Appendix E – Submissions, 10 August 2021

Alteration of Britomart Transport Centre Designation 2501

Response to clarifications on Notice of Requirement to Alter City Rail Link Limited Designation 2501 in the Auckland Unitary Plan (Operative in Part)

Figure 1 Soundsplash image for a 2 metre high noise barrier

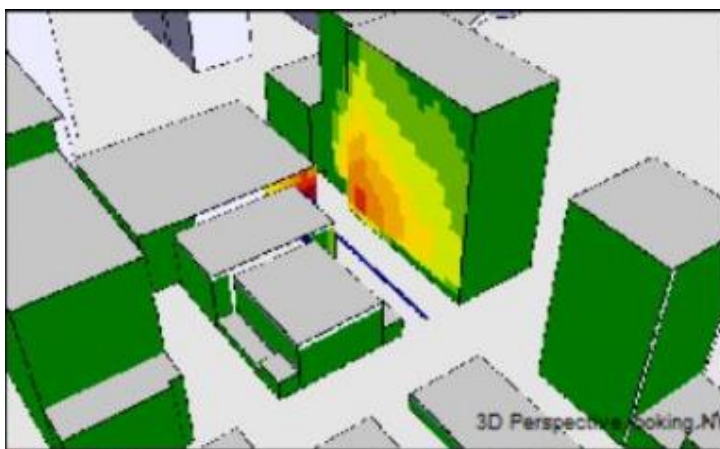
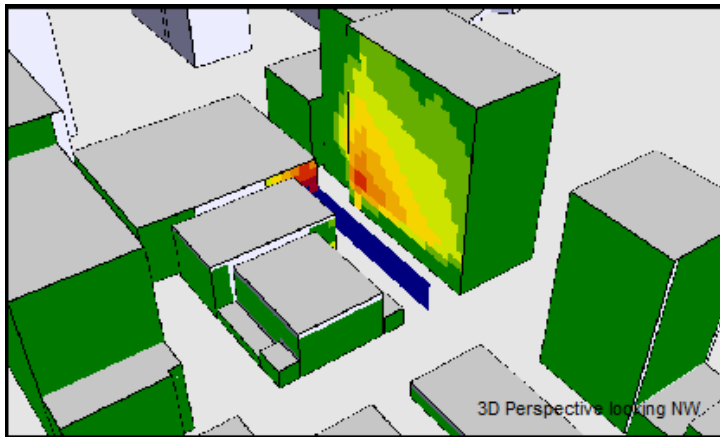
I consider that there could be considerable benefit from additional screening of the concrete delivery area, with a partial enclosure / roof being likely to provide an additional 8-10dB of screening. This would subjectively reduce the noise levels by around half. I consider that such a reduction in effects is worthwhile pursuing given the duration and intensity of the noise levels proposed in this alteration.

The CRL project noise specialist (James Whitlock from Marshall Day Acoustics) confirms that a 10-metre high acoustic barrier (which is taller than would be practicable) was modelled. Soundsplash images for a 2-metre and 10-metre high barrier are shown respectively in Figure 1 and Figure 2 below. The images illustrate that even a 10-metre high barrier cannot achieve compliance on the façade of buildings on the north side of Tyler Street due to the geometry of the situation. As a higher barrier would not provide any additional benefit, it is considered that a 2-metre barrier is the best practicable option.

A partial acoustic enclosure was not modelled by the noise specialist as the construction team have confirmed it is infeasible to establish an enclosure in this area of the proposed site compound, due to both vertical and horizontal space constraints. Within the same area, the construction team must allow for:

If a fixed structure such as a partial enclosure was to be introduced in this immediate area, it would hinder the construction team's ability to undertake the Works. Tyler Street is the main area for material deliveries and the aim of the proposed moveable site compound fence is to provide ease of access and the ability to manoeuvre in a constrained space. The acoustic barrier will be integrated with the site compound fence along Tyler Street.

Britomart NOR CTMP Concrete Truck Tracking (Peak)

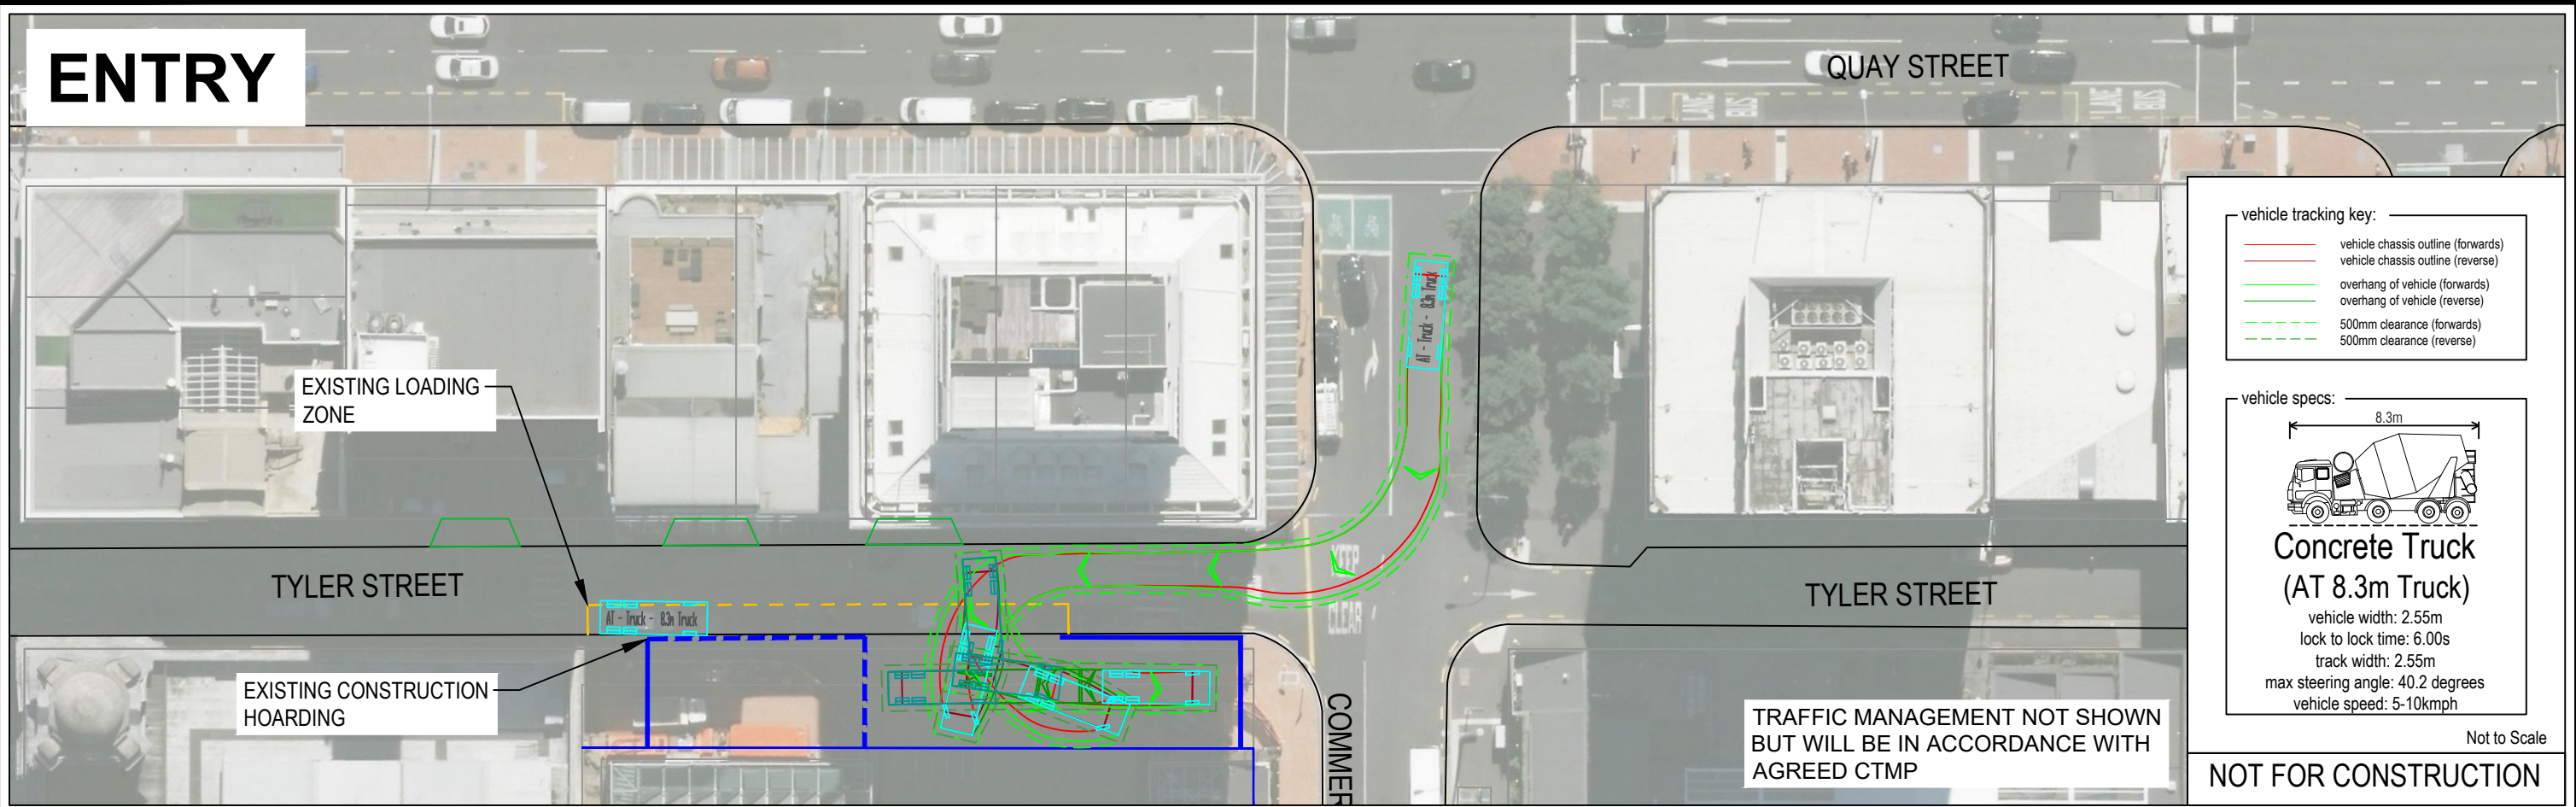
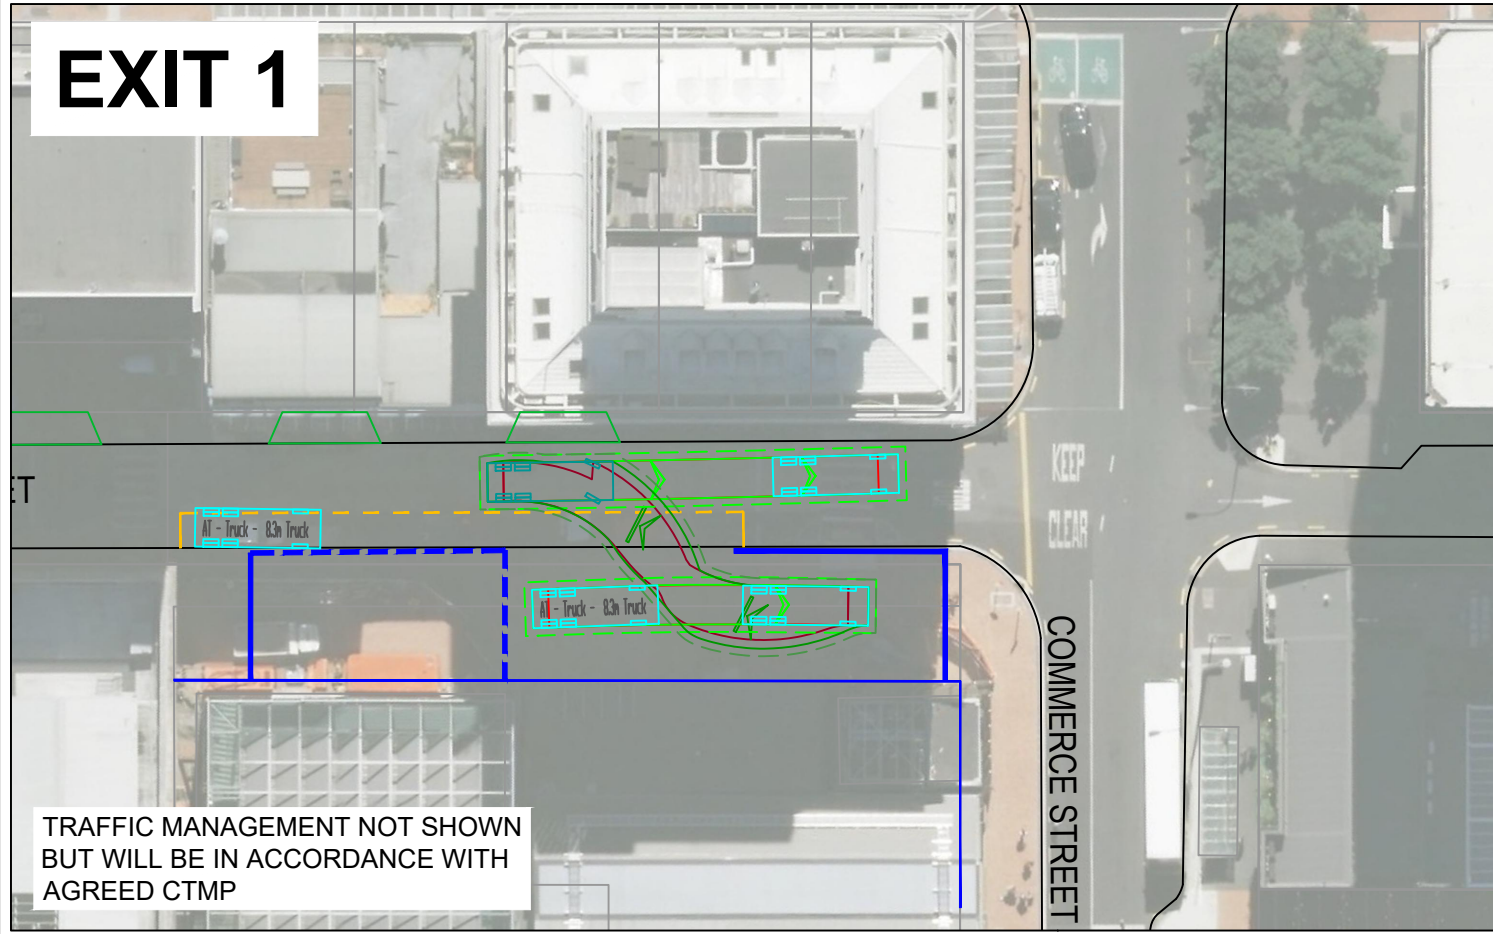
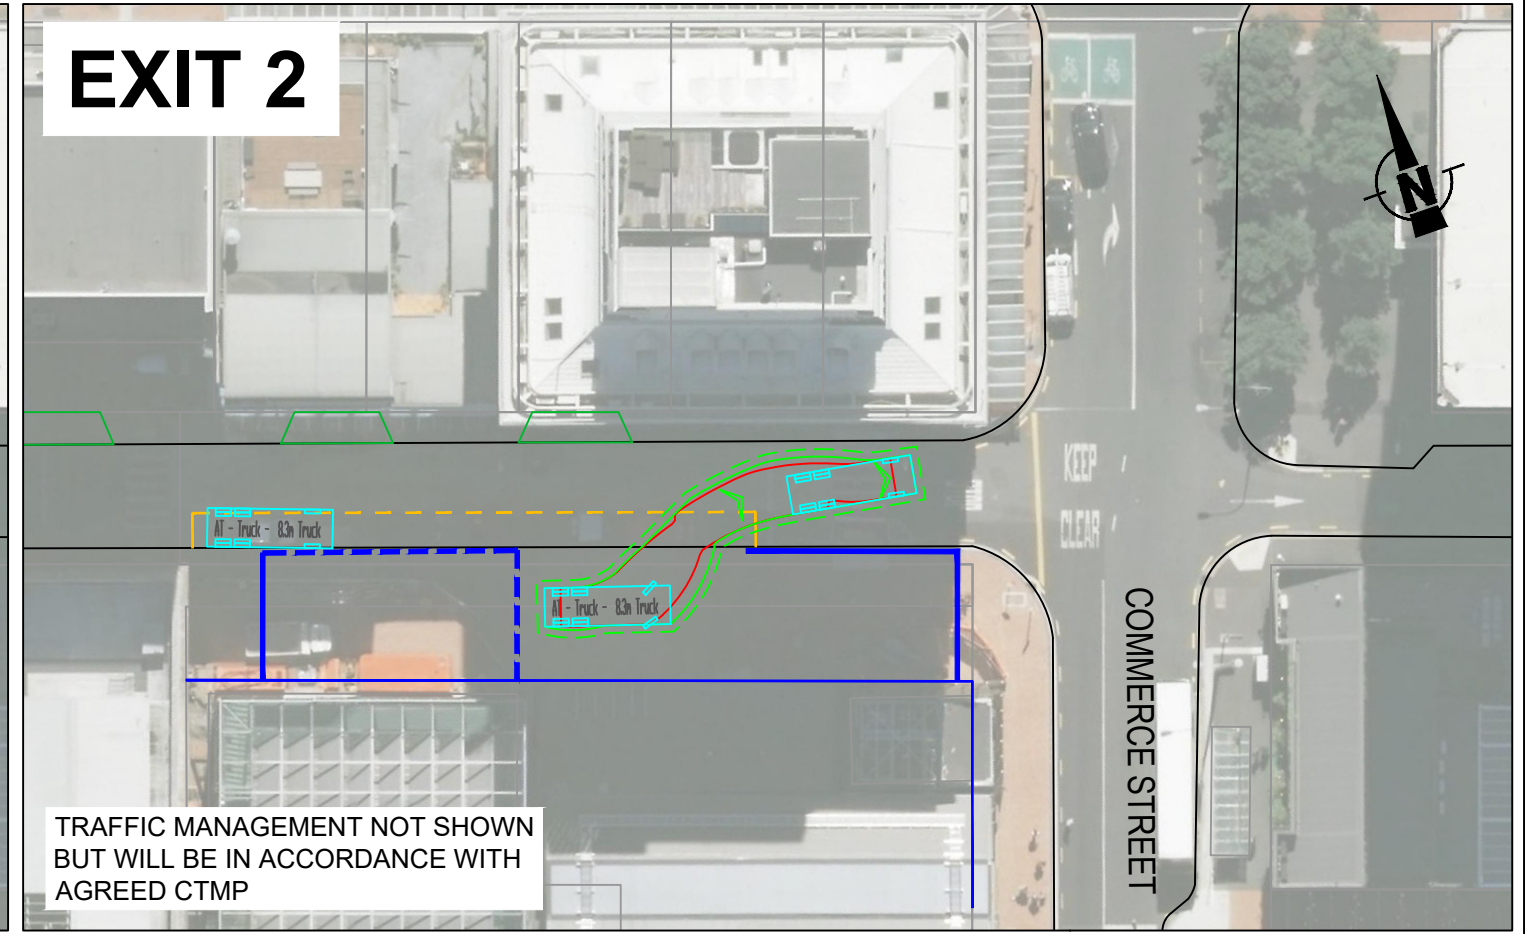
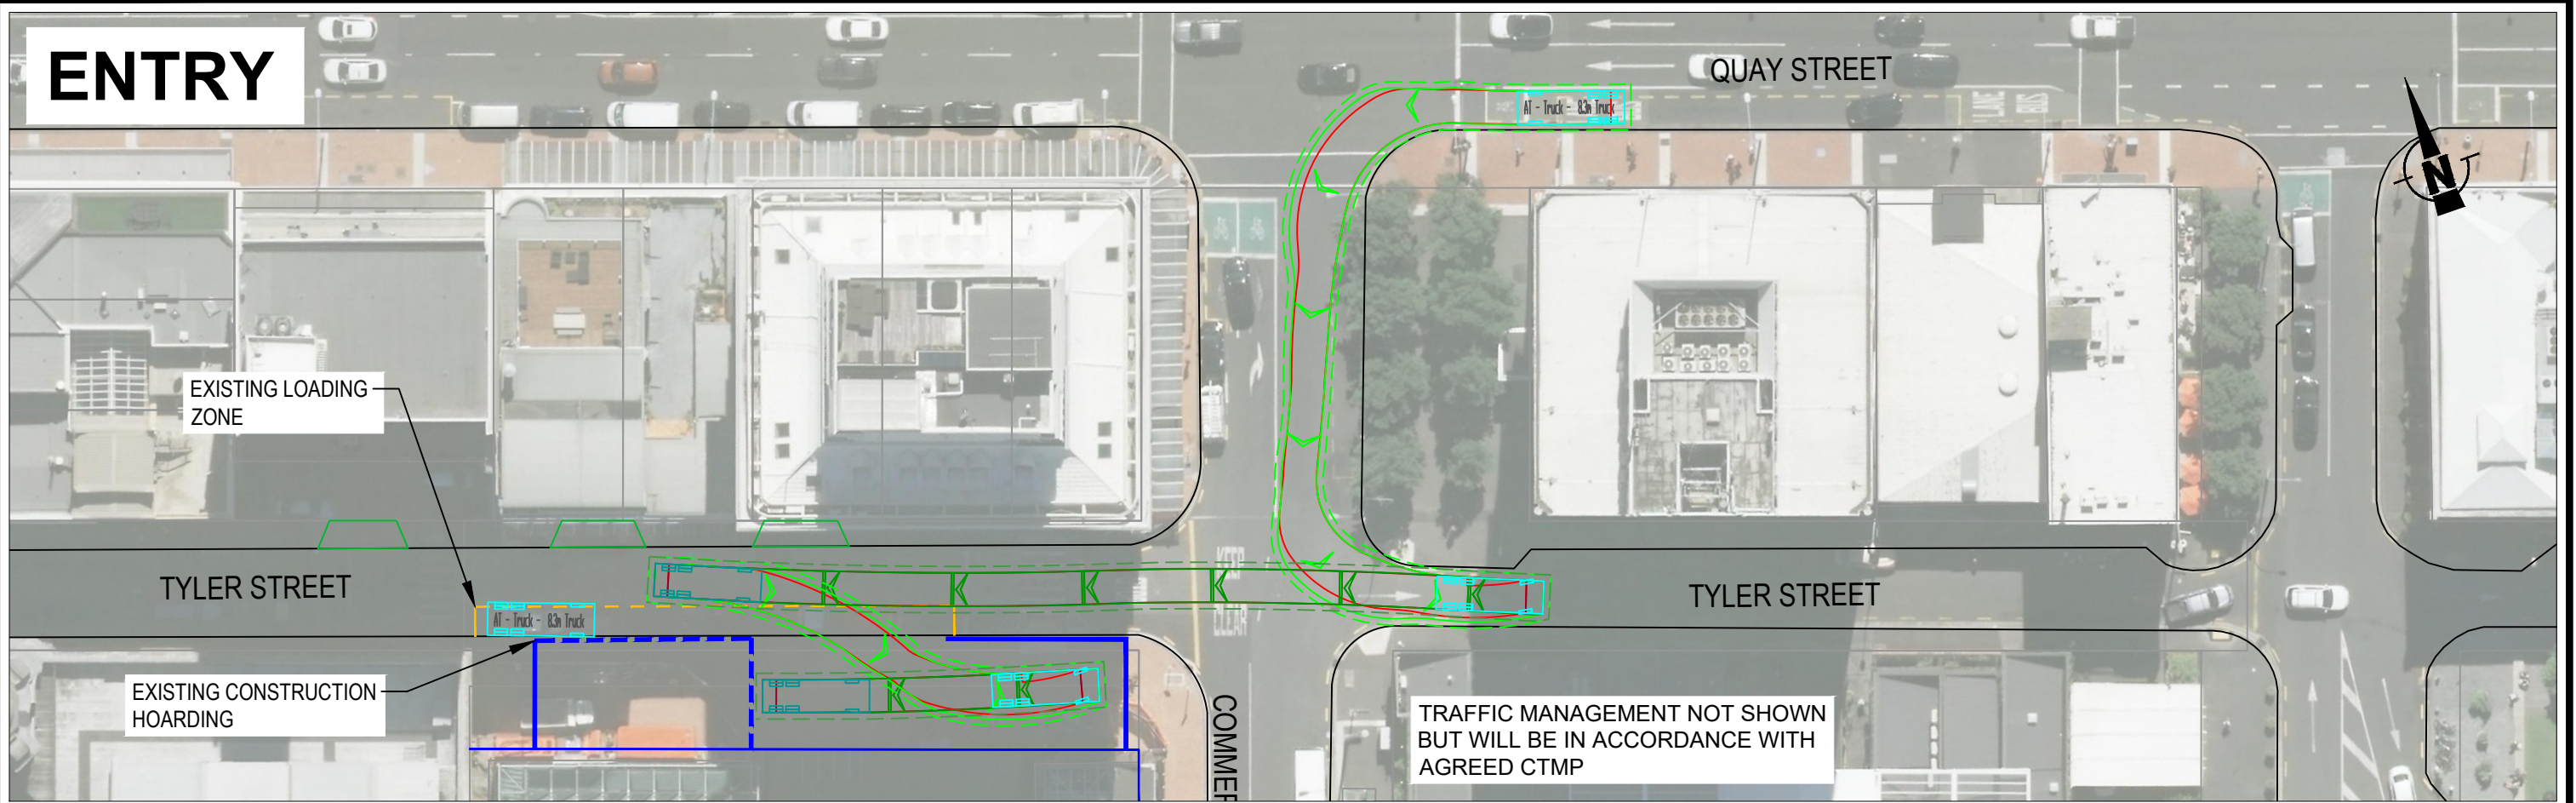
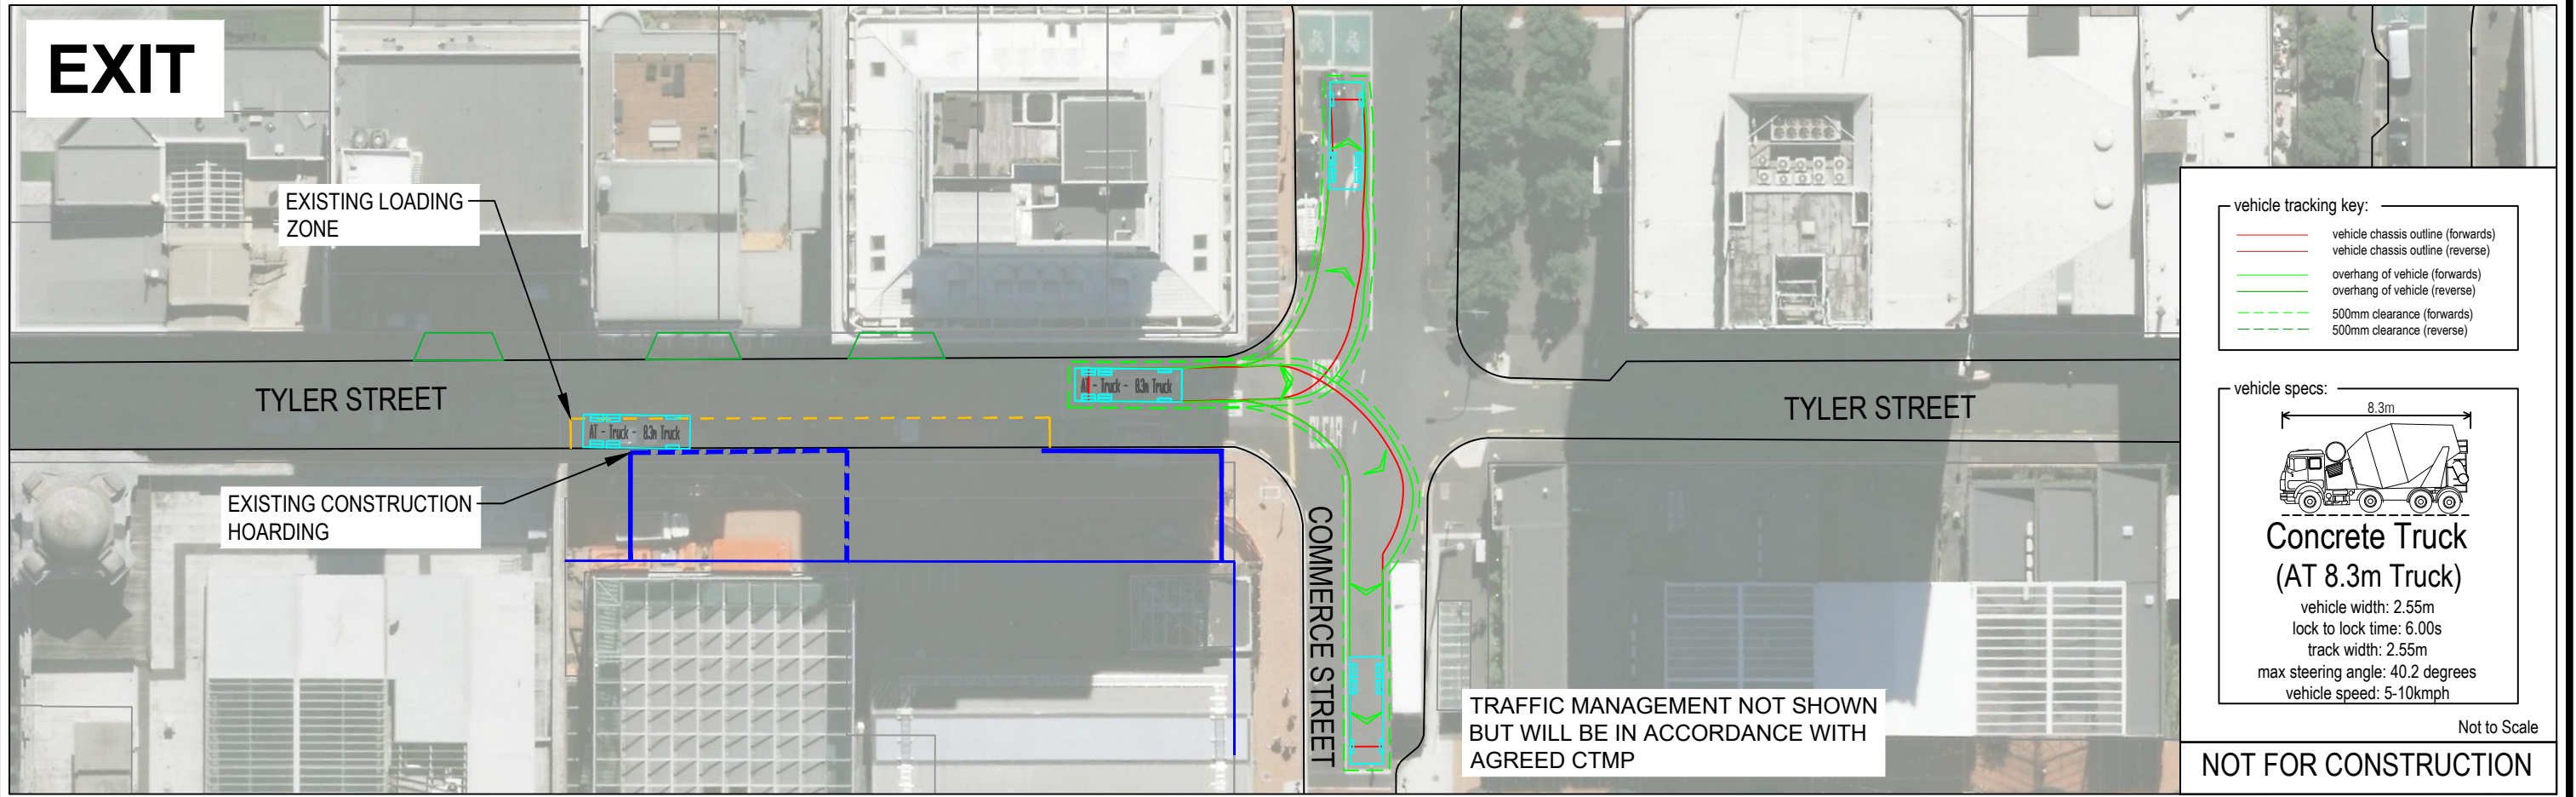
From the vehicle paths shown in the s92 response, there are some complex movements for both these that will be carried out in the peak periods (within Tyler Street) and those that will be undertaken in the inter-peak period (including reverse movements into Tyler Street). These will require specific temporary traffic management in accordance with the Waka Kotahi Code of Practice for Temporary Traffic Management processes, which are to be approved by Auckland Transport, which have a robust process of documentation, approval, implementation and monitoring. An example layout plan previously approved and implemented for reversing a truck into Tyler Street indicates that the required traffic management will be feasible.

We refer to the Concrete Truck Tracking drawings in Attachment 2 of the section 92 response dated 26 July 2021, which further illustrate the space constraints of this part of the site. These drawings are reattached as **Attachment 1** for ease of reference.
